STAFF RECOMMENDATION
1430-B Greenwood Avenue
December 20, 2017

Application: New construction – infill (Revision to previously approved plan)
District: Eastwood Neighborhood Conservation Zoning Overlay
Council District: 06
Map and Parcel Number: 08302037100
Applicant: David Baird
Project Lead: Melissa Baldock, melissa.baldock@nashville.gov

Description of Project: Application is to revise a previously-approved infill design. The applicant seeks to add a side bay, add a rear chimney, and to alter window openings.

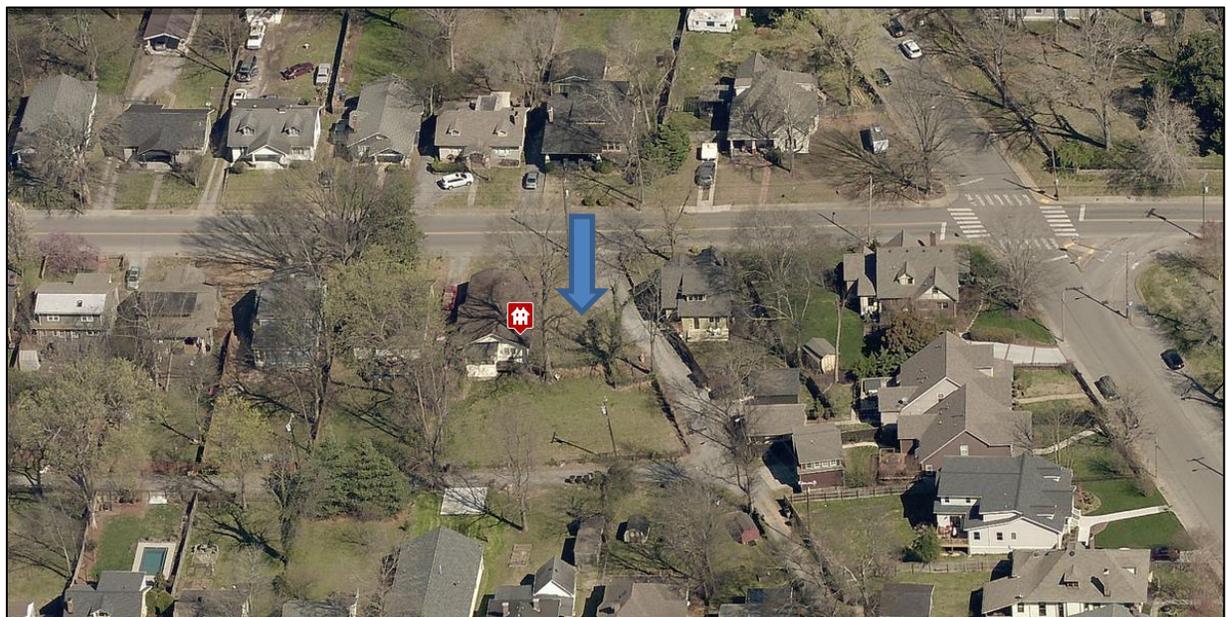
1. The finished floor height be consistent with the finished floor heights of the adjacent historic houses, to be verified by MHZC staff in the field;
2. Staff approve the final details, dimensions and materials of windows and doors prior to purchase and installation;
3. Staff approve a brick sample;
4. Staff approve the roof shingle color and texture; and
5. The HVAC shall be located behind the house or on either side, beyond the mid-point of the house.

Figure 3 (left) is the previously approved plans. Figure 4 (right) is the current proposal, which includes transoms above the double window opening on the front.

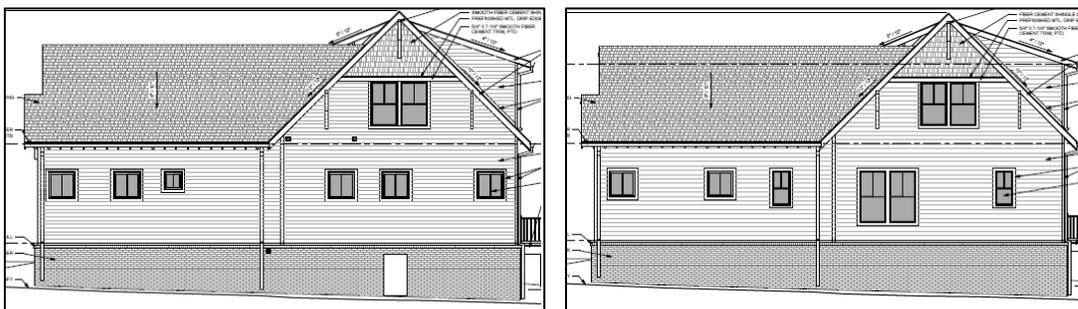
Proportion and Rhythm of Openings: The revised drawings do involve alterations to the window openings on the front and right facades (Figures 2-5). Staff finds that the revised fenestration pattern meets the design guidelines. The windows are approximately twice as tall as they are wide, meeting the historic proportion of openings. There are no large expanses of wall space without a window or door opening. Staff finds that the project’s proportion and rhythm of openings meet Section II.B.1.g. of the design guidelines.

Figure 4 (left) is the previously approved plans. Figure 5 (right) is the current proposal.
